WILSON'S WOLF RIDGE ROAD SUBDIVISION

APPLICATION NUMBER 30 DATE May 6, 2004

REQUEST Subdivision

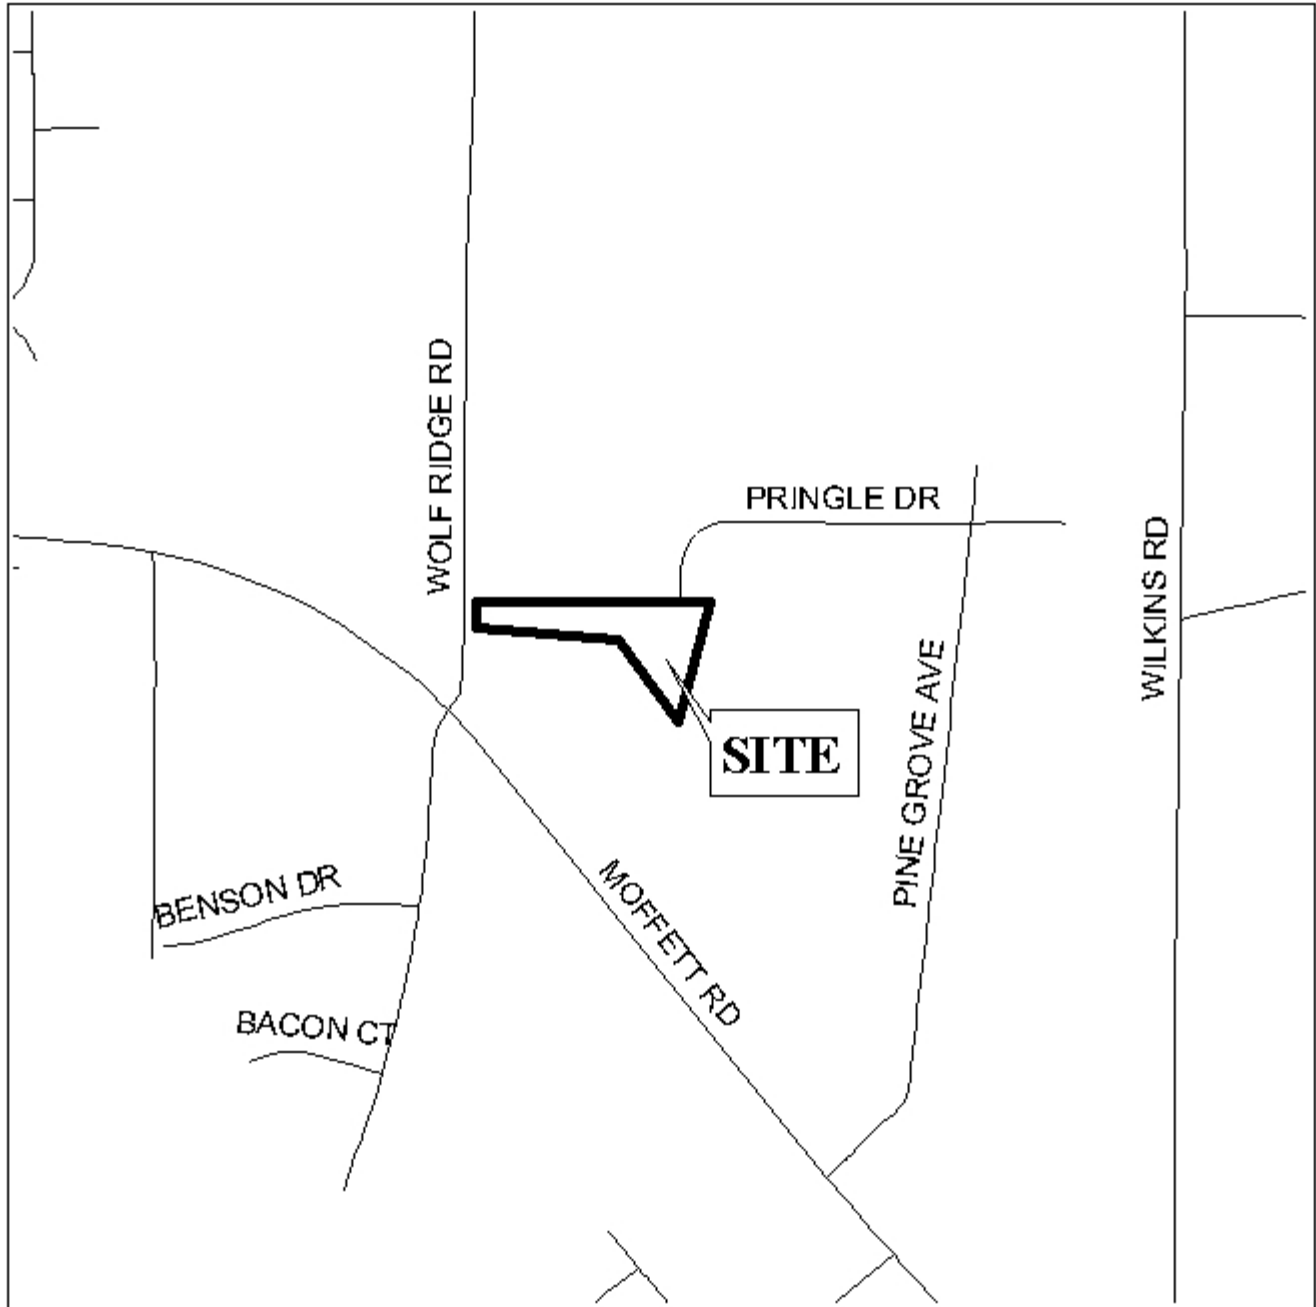
The plat illustrates the proposed 1 lot, 1.3 \pm acres subdivision which is located on the East side of Wolf Ridge Road, 200' \pm North of Moffett Road and is in City Council District 1. The subdivision is served by public water and sanitary sewer.

Wolf Ridge Road, which has an existing right-of-way of 50-feet, is shown as a major street on the Major Street Plan, and as such requires a 100-foot right-of-way; therefore, the dedication of sufficient right-of-way to provide 50-feet from the centerline should be required. Additionally, as a means of access management, a note should be placed on the final plat stating that the site is limited to one curb cut to Wolf Ridge Road, with the location, size, and design to be approved by Traffic Engineering, should be required.

A note should be placed on the final plat stating that the site is denied direct access to Pringle Drive.

As proposed, the site would exceed the maximum width to depth ratio, therefore a waiver of Section V.D.3. of the Subdivision Regulations would be required.

With a waiver of Section V.D.3., the plat will meet the minimum requirements of the Subdivision Regulations and is recommended for Tentative Approval subject to the following condition: 1) the dedication of sufficient right-of-way to provide 50' from the centerline of Wolf Ridge Road; 2) the placement of a note on the final plat stating that the site is limited to one curb cut to Wolf Ridge Road, with the location, size, and design to be approved by Traffic Engineering; and 3) the placement of a note on the final plat stating that the site is denied direct access to Pringle Drive.
